Southern California Edison Company

Subject: Docket No. 50-206
Transshipment of Spent Fuel
San Onofre Nuclear Generating Station
Unit 1

Since an error was discovered in our submittal of April 25, 1988 which affected the NRC determinations regarding the acceptability of our plans for Transshipment, a detailed review of our previous submittals on the subject has been conducted. A listing of submittals reviewed, the results of this review and the corresponding corrections and clarifications are provided in the enclosure.

The following corrections and clarifications have been identified:

Figure 1

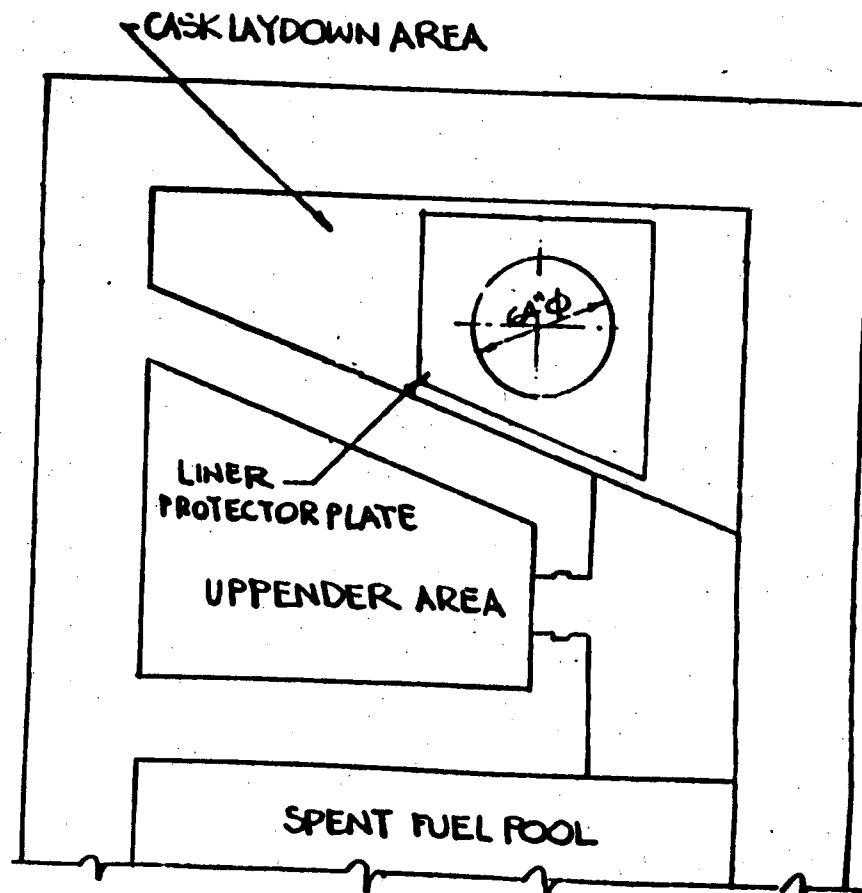
CASK IN SPENT FUEL POOL. UNIT 1

PARTIAL PLAN

OMISSION

The dimensions of the impact limiter are shown in Figure 1.

Figure 2

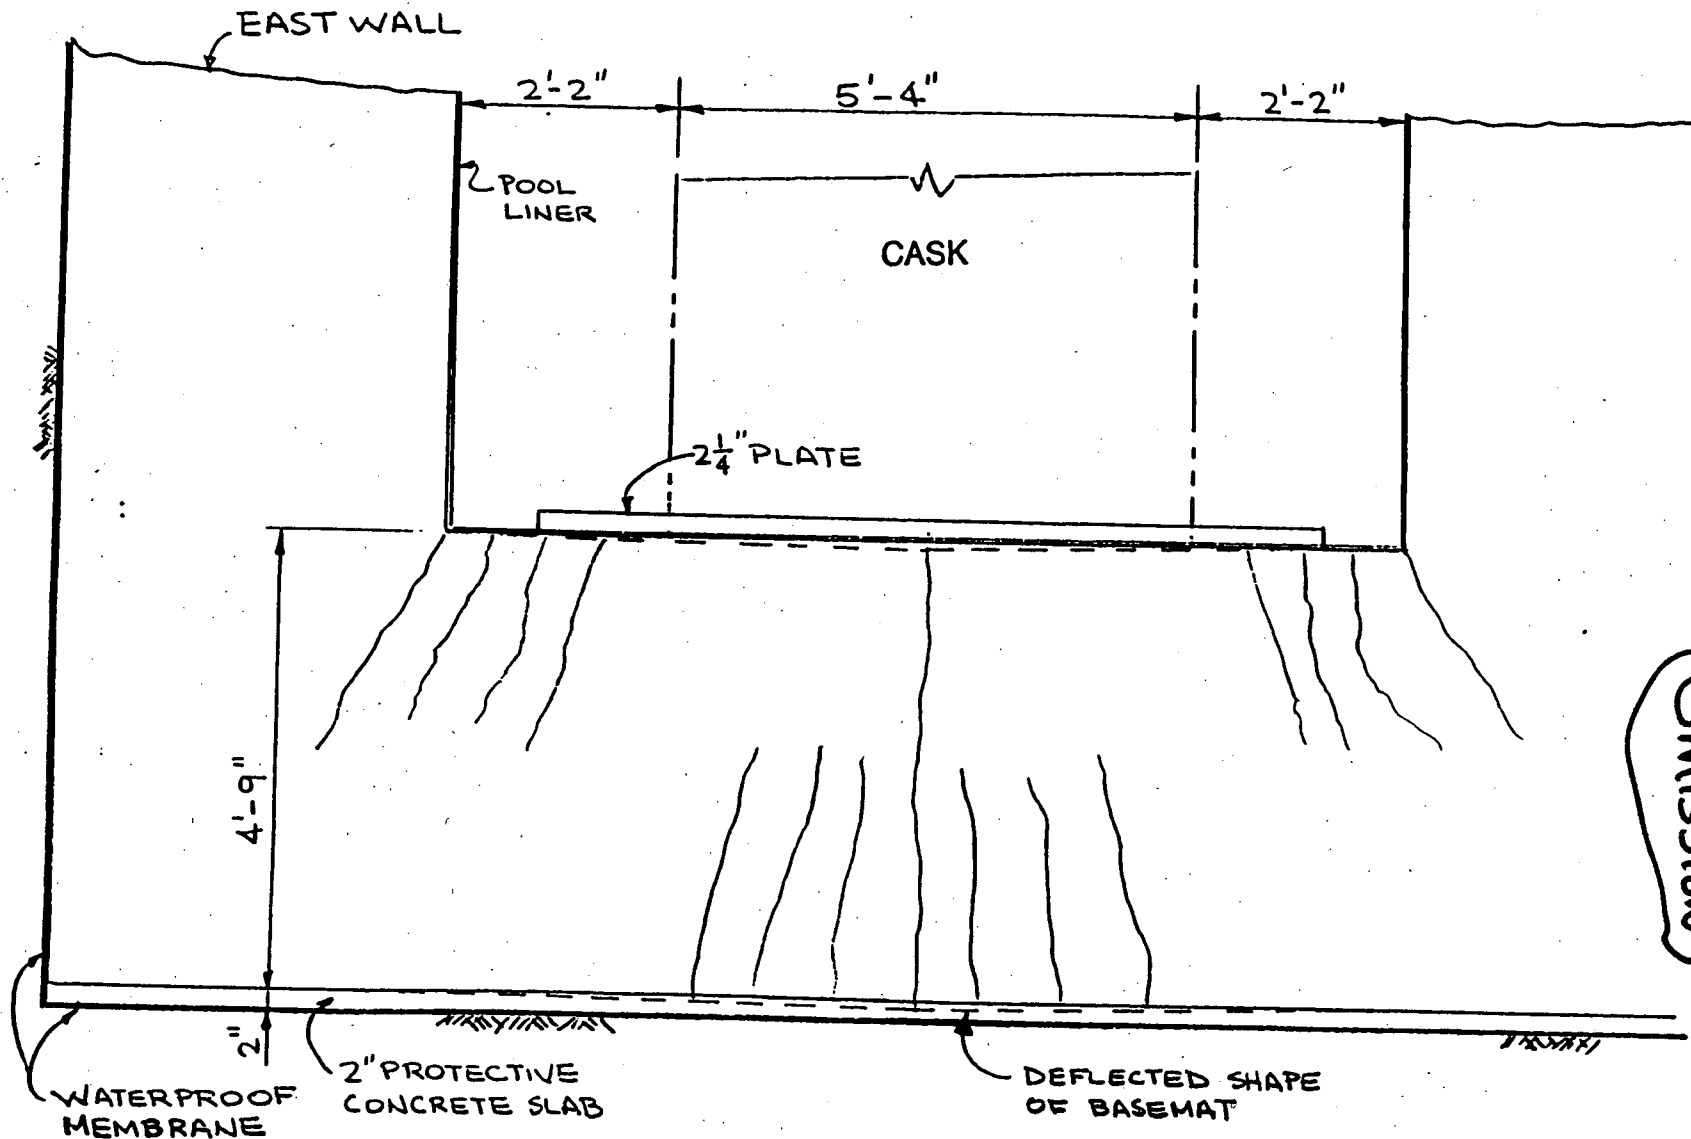
The reinforced concrete basemat is 4'-9" thick and has an average span of 9'-8" at the point of cask laydown (see Figure 2). The ability of the basemat to withstand the cask impact force was evaluated by considering the basemat as a beam spanning between the pool walls and also as a footing.

In conservatively assuming one-way beam action and no soil resistance under the basemat, the maximum moments are 9667 k-ft at the center and -16,971 k-ft at the support ends. Since the cracking moment capacity of 4358 k-ft is exceeded, cracking can be presumed to occur in areas of exceedence as shown in Figure 2.

The cracking in the concrete will not allow water leakage into the soil because there is a waterproof membrane encompassing the entire basemat up to Elevation 12 feet. In addition, any water leakage will follow the path of least resistance which is the leak chase system.

OMISSION
